Document title: Response to NMED NOD (Part 1) on MWL CMI Plan, December 2006

DOE/Sandia Responses to NMED's "Notice of Disapproval: Mixed Waste Landfill Corrective Measures Implementation Work Plan, November 2005"

Comment Set 1

Part 1. Comments on Landfill Construction Plans and Performance Modeling

6501 AMERICAS PARKWAY N.E., SUITE 900 ALBUQUERQUE, NEW MEXICO 87110 (505) 855-7500 FAX: (505) 855-7555 EXHIBIT #2

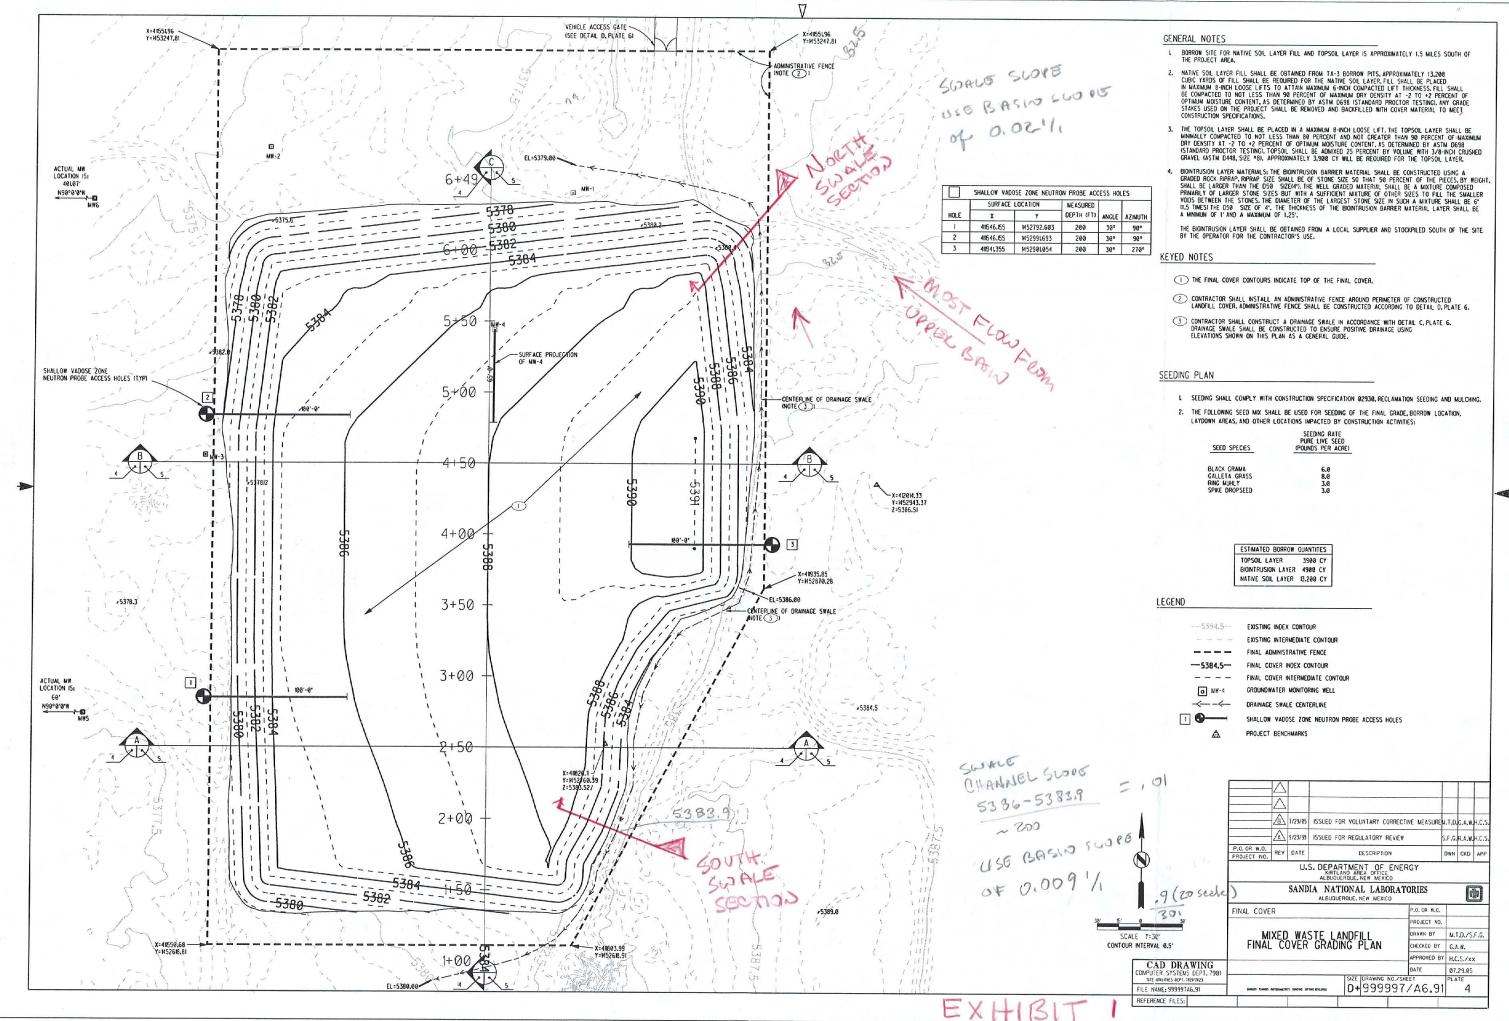
16. Demonstrate with calculations and other information whether run-off and run-on controls have been adequately designed to handle peak precipitation events. Evaluate and discuss whether additional run-on controls should be constructed at locations further away from the landfill (e.g., at distances of 25 to 50 meters) to provide more protection for the cover from heavy rainfall events.

The watershed basin draining onto the site has been delineated and is shown on Exhibit 2 of Attachment 3. It is divided in to a north basin and a south basin that drain to the north and south swales respectively.

Runoff was calculated using the City of Albuquerque Development Process Manual (City of Albuquerque 2006) criteria for the 100 year –6 hour storm. The north basin generates 24 cfs and the north swale has the capacity for 79 cfs. The south basin generates 6.5 cfs and the capacity of the south swale is 58 cfs.

The swales are therefore sized with abundant capacity to prevent flow from entering the site and to carry the runoff around the site.
